CLASS I SERVICE INSTRUCTIONS

No. 1193
ATA Code 55-10

SUBJECT: STABILIZERS - INSPECTION OF HORIZONTAL STABILIZER ATTACH BOLTS

VIEW LOOKING FORWARD

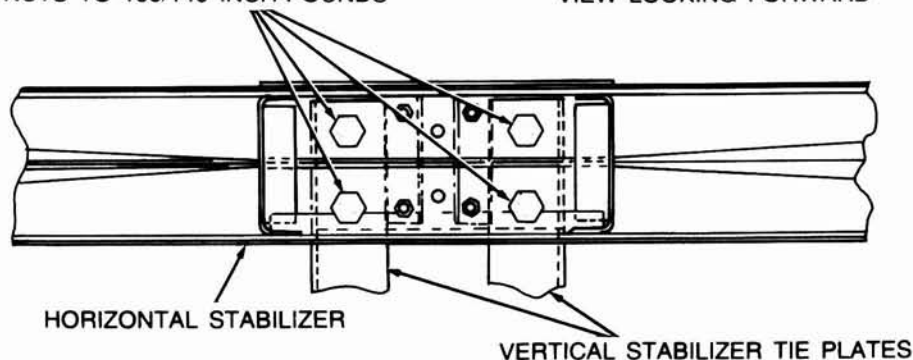
2. Inspect the four outboard bolts which secure the horizontal stabilizer forward spar to the vertical stabilizer tie plates for correct length and number of washers installed.

4. If a bolt change is necessary or additional washers are required, refer to the illustration for correct assembly.

NAS1105-3 /M/ BOLT
AN960-516 WASHER
(4 EA. REQ.)

TORQUE EXISTING
NUTS TO 100/140 INCH-POUNDS

/M/ bolts may be used providing that two AN960-516 washers are installed. (The part number and dash number of the bolt should be marked on the bolt head.)

3. If the correct bolts and washers are installed as described above, check to ensure that the nuts are torqued to 100/140 inch-pounds.

The correct bolts should be NAS1105-3 /M/ and should have one AN960-516 washer installed under the nut, however, NAS1105-4
